This project description is for a proposed 'Rock Filter Vineyard Protection Plan' erosion control and abatement at 22507 River Road, Sonoma County (APNs 141-190-057 and -056 (See Attached plans)).

**Subject: Plan Review Comments for Vimark Vineyards
22507 River Road, Geyserville, CA
APN 141-190-057 ✓ 6
County Project # GRD05-0118 ~~GRD05-0236~~
~~110-110-0116~~**

6601 Koll Center Parkway
Suite 140
Pleasanton, CA 94566925-426-0080
FAX 925-426-0080
<http://www.scsengineers.com>**SCS ENGINEERS**August 25, 2006
File No. 01203338.01Mr. Reg Cullen, Engineer
County of Sonoma Permit and Resource Management Department
2550 Ventura Avenue
Santa Rosa, California 95403**Subject: Cumulative Base Flood Impact
Proposed Rock Filter for Vimark Vineyards
22507 River Road, Geyserville, CA
APN 141-190-057
County Project # GRD05-0118**

Figure 1 – Aerial View of Alexander Valley

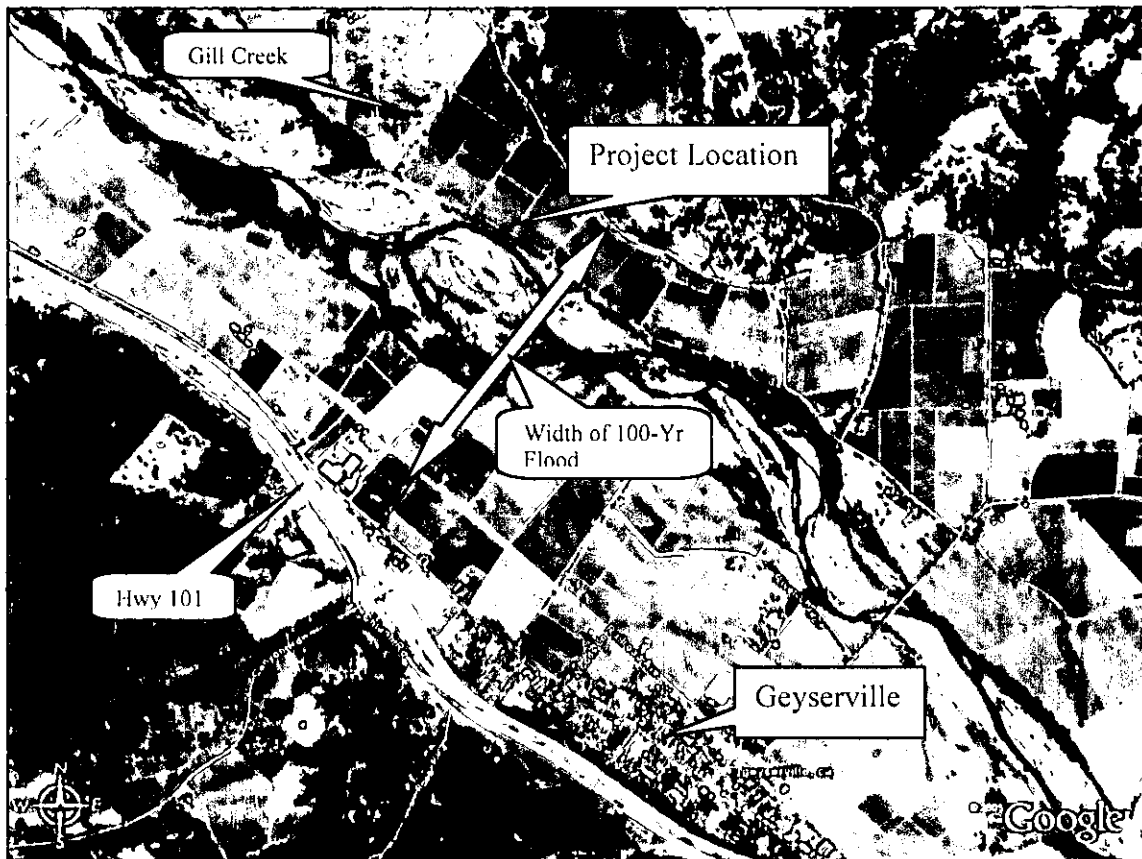
- 9a). ***At or near the project area calculate or show the cross-sectional area of the Russian River, show the cross-sectional area of the rock filter, and calculate the decrease in cross-sectional area of the Russian River based on the introduction of rock to form the filter. Describe the impact of this decrease in cross-sectional area on water surface elevations for the 100-year event.***

The triangular area of rock (25 square feet in cross section) has infinitesimally small (00.1%) influence on the cross-sectional area of the river (4,500 feet wide and assuming average depth of 5 feet equals 22,500 square feet). The river cross-sectional area and wetted perimeter at flood is not changed as the rock is porous and water will flow right through finding its natural lateral boundary.
